ARCHITECTURAL REVIEW BOARD AGENDA

October 11, 2016 – 7:30 p.m.

**MINUTES
REGULAR MEETING
CITY OF MANASSAS
ARCHITECTURAL REVIEW BOARD**

**ARCHITECTURAL REVIEW BOARD
No. 17-4000005**

**ARCHITECTURAL REVIEW BOARD
No. 16-4000037**

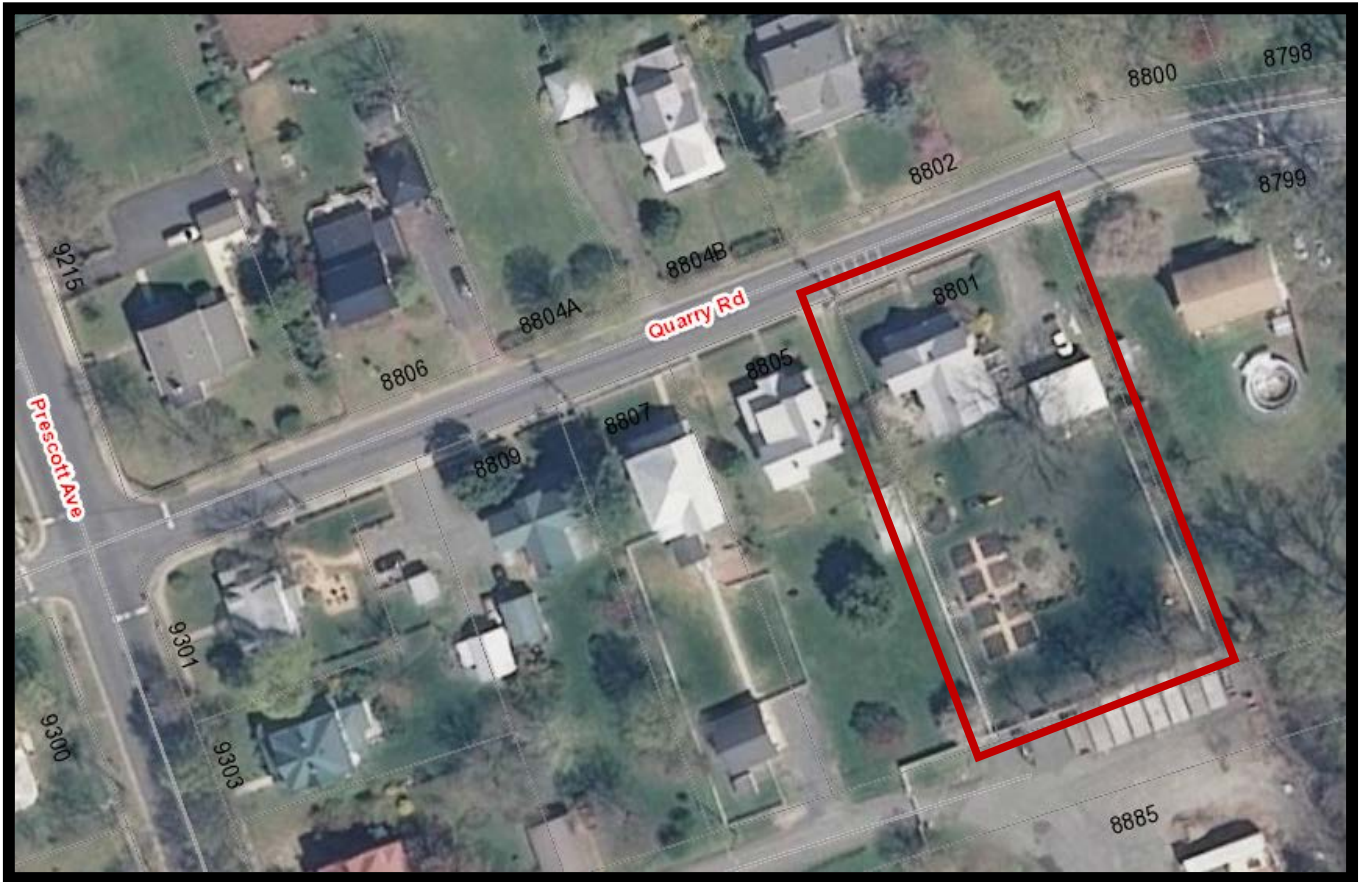
Overall, the revised scale and design of the addition is compatible with the massing and scale of the home. The revised layout and location maintains the integrity and balance of the front elevation. The side elevation of the addition continues the symmetrical window placement seen on the original block of the home. The design maintains the corner trim board, and is slightly set back from the elevation of the original massing of the building, serving to differentiate between the addition and the original block of the home.

Overall, the proposed materials are in keeping with the guidelines and are compatible with the existing materials on the home. While synthetic windows are generally not recommended for use on historic homes, the fiberglass composite windows will be located on a modern addition located at the rear of the home where visibility from the street is minimized. Staff requests samples of the proposed stone foundation veneer be provided at the meeting to verify compatibility with the structure and existing foundation materials.

(5) The texture, material and color of new construction, unless otherwise exempt from review.	Overall, the proposed materials are compatible with the home. Staff requests samples of the roofing and foundation veneer materials for verification.

Staff recommends **APPROVAL** of the application as submitted. A sample of the stone foundation veneer should be provided for review.

**ARCHITECTURAL REVIEW BOARD
No. 17-4000009**

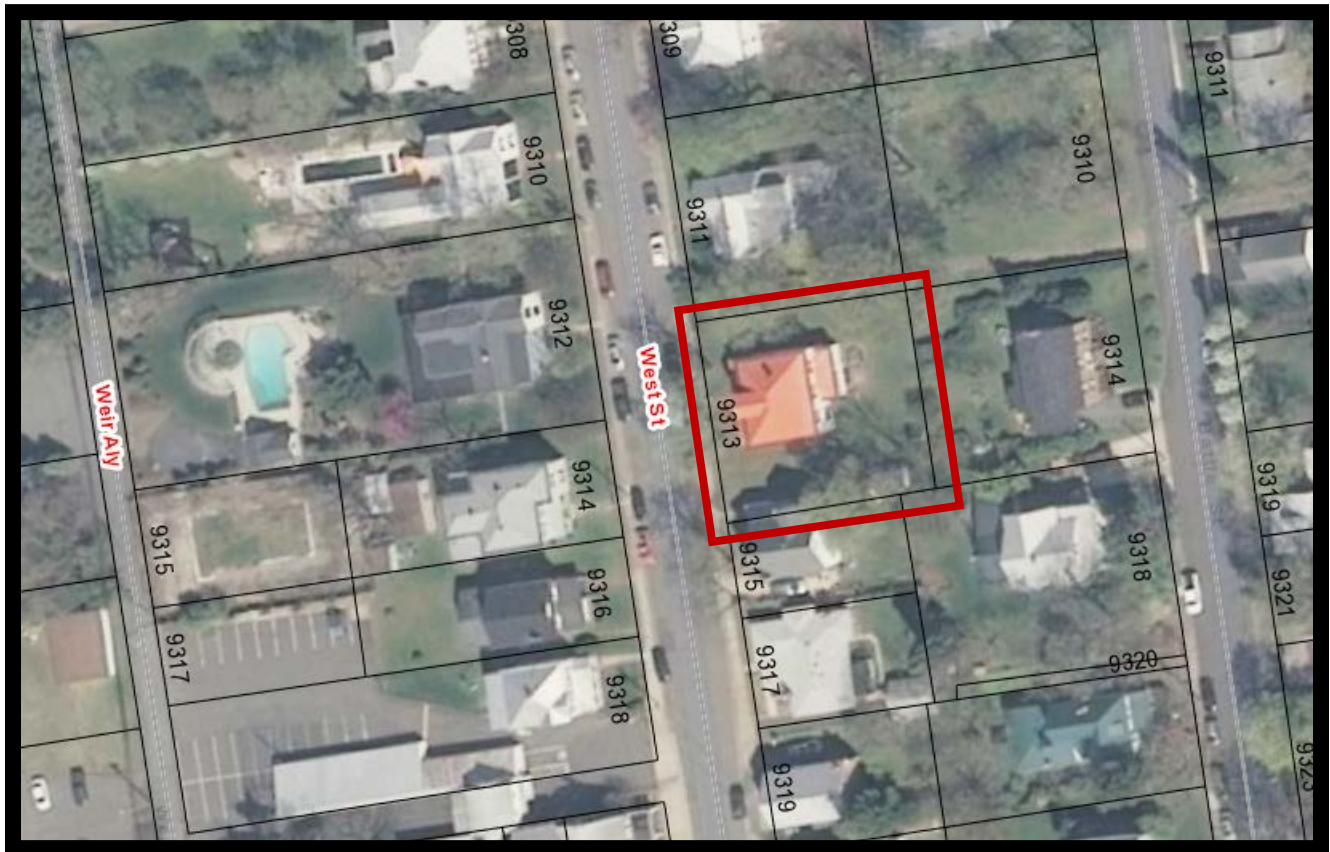
The proposed garage is located in the rear yard. While it will be partially obscured by the home, it will still be largely visible from the public street. The scale and massing of the garage is secondary to the home and appropriate for the site. While the design is simple, some additional detailing could provide greater compatibility with the design of the home, such as adding fish-scale shingles in the gables and considering circular gable windows as opposed to 1/1, echoing the design of the gable on the home. In addition, staff finds that the two windows with shutters proposed on second floor of the gable ends crowd the elevation. Staff recommends considering a single window on the gable.

(2) The harmony of the proposed change in terms of overall proportion and the size and placement of elements such as entrances, windows, awnings, exterior stairs, and signs.	Additional detailing, such as fish-scale shingles and circular windows in the gables, could provide greater compatibility with the character of the home. The proposed two windows with shutters on the second story of the gable ends of the garage crowds the elevation.

Staff recommends **APPROVAL** of the application with the recommendation that additional detailing be provided, such as fish-scale shingles in the gable and only one window on the second floor gable end elevations.
